## SERVICE BULLETIN 13-12-19

**Subject:** Fuel Tank Attach Modification

**Affected Models:** All RV-12 Fuel Tanks shipped prior to December 19, 2013  
All SLSA RV-12 serial numbers 12019 and below.

**Required Action:** Install T-01220 Doublers and Upgrade T-1205 attach hardware.

**FIGURE 1:** SEPARATING THE DOUBLERS

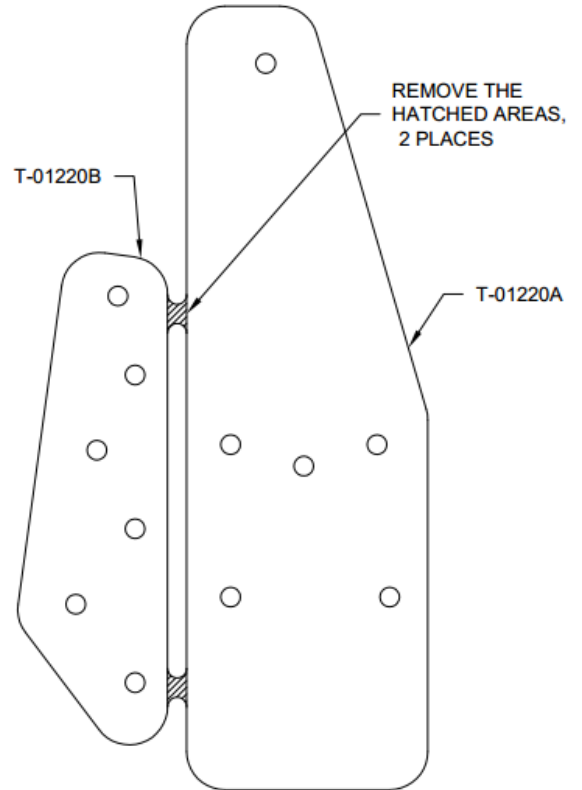
**Step 4:** Separate T-01220 Doubler into A & B parts as shown in Figure 1.

**FIGURE 2:** REMOVING INBOARD RIVETS AND NUTPLATES

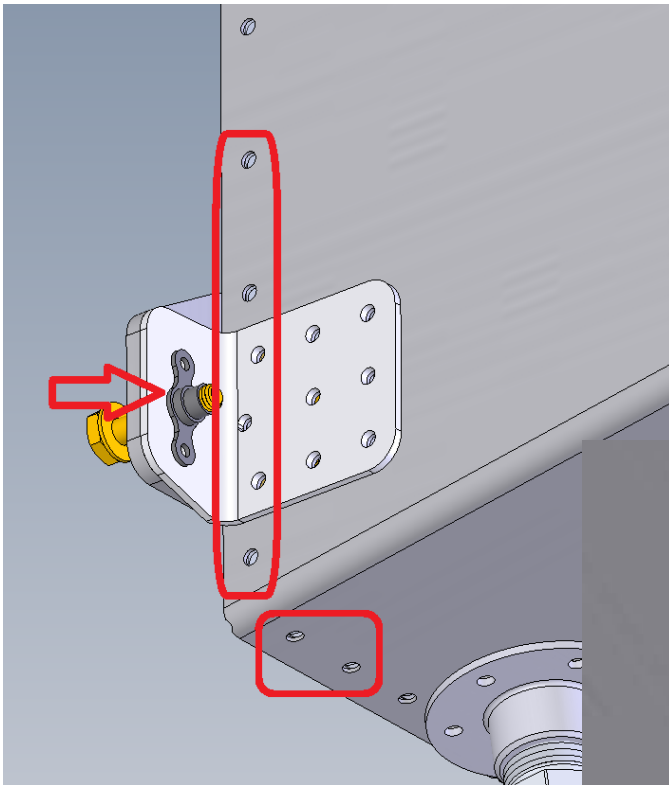
**Step 5:** Remove the two K-1000-3 nutplates attached to the T-1205 Fwd Tank Bracket and save them for reinstallation later (Reuse of the old nutplates is beneficial. Since they have already had a bolt inserted, the prevailing torque of the locking feature will be lower which reduces the risk of over torquing and fracturing the frangible bolt). Removal of the rivets common to the doublers and other rivets depicted will greatly help with the removal process of the existing sealant. See Figures 2 and 3. See KAI Chapter 5 for further information on removing rivets.

**FIGURE 5: INSTALLING THE DOUBLERS**

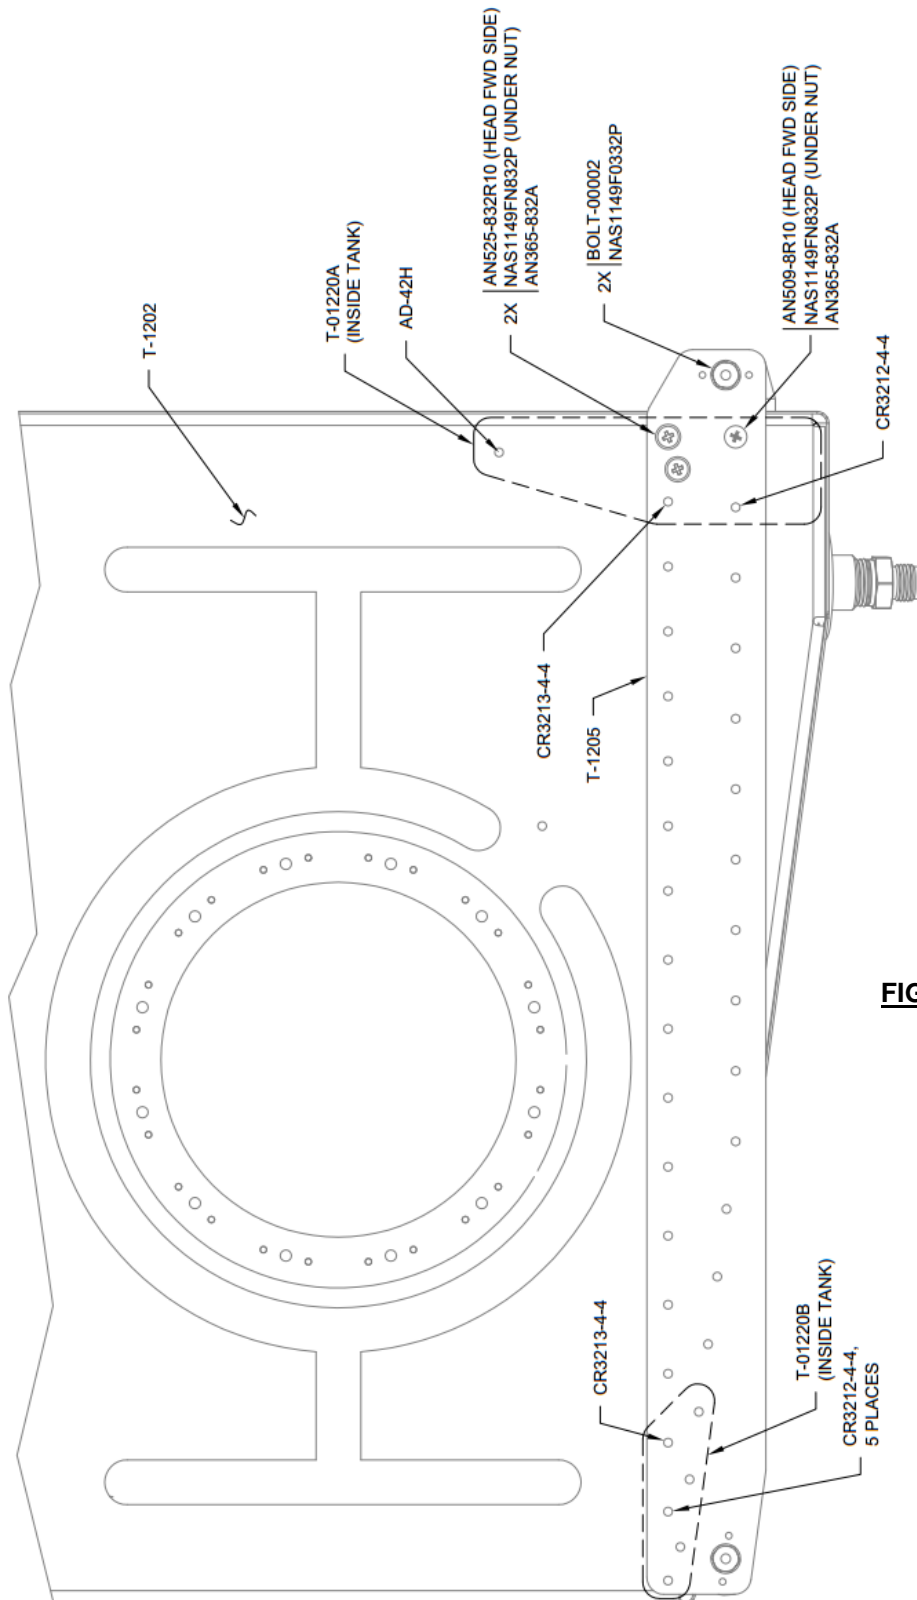
Step 8: Test fit the doublers inside the tank. Radius the edges of the doublers to fit against the bend radii in the T-1202 Fwd Tank Bulkhead. See Figure 5.

Step 13: Add a very thin layer of sealant covering the face of the doublers that will lay against the T-1202 Fwd Tank Bulkhead. Using the hardware callouts shown in Figure 5 rivet the doublers to the tank structure using tank sealant. Refer to Section 5 for installation of Cherry Max rivets.

Step 14: Install the screws common to the inboard doubler as shown in Figure 5.
